Town of Rolesville, NC
Department of Planning

Comments on #PSP-26-0002 - Planning & Zoning: Preliminary Subdivision Plat

Application Number: #PSP-26-0002
Application Type: Preliminary Subdivision Plat
Date: October 1, 2026
Address: 2206 Wait Ave Wake Forest NC 27587

ATTICUS WOODS

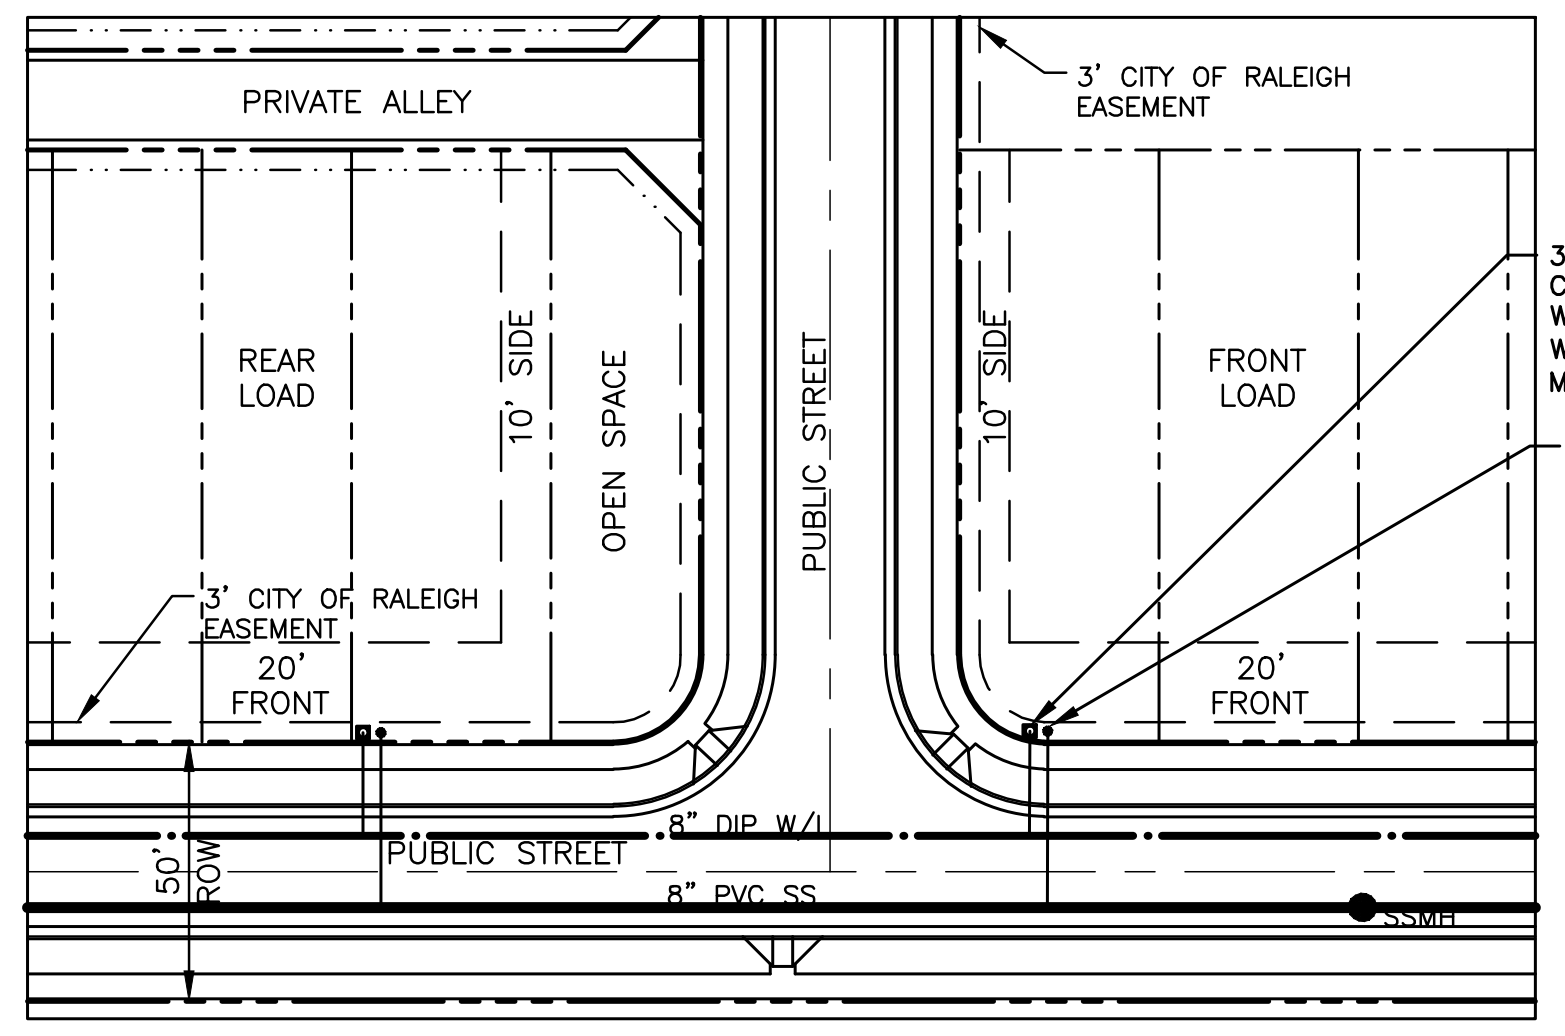
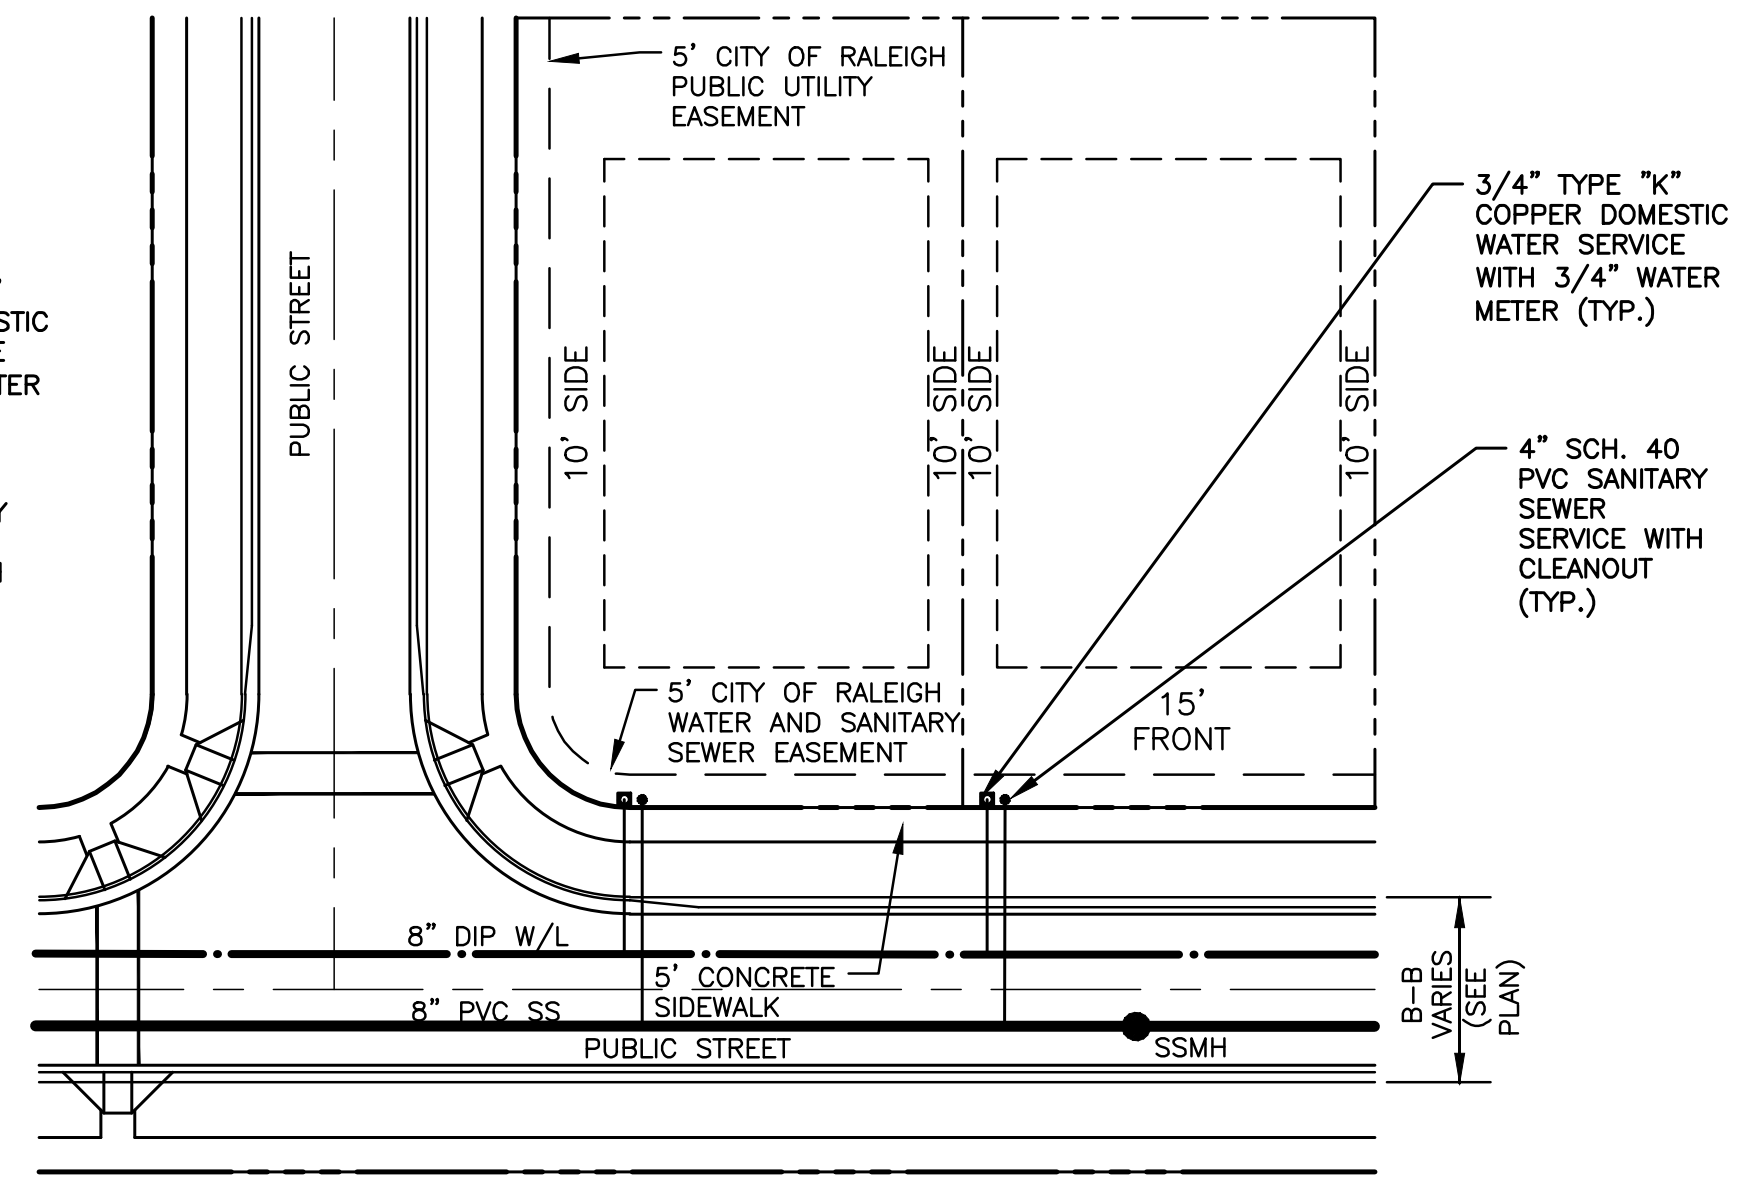
6. Where are your water and sewer services for the lots?
    McAdams Response: Added typical lot service layout to sheet C4.00.
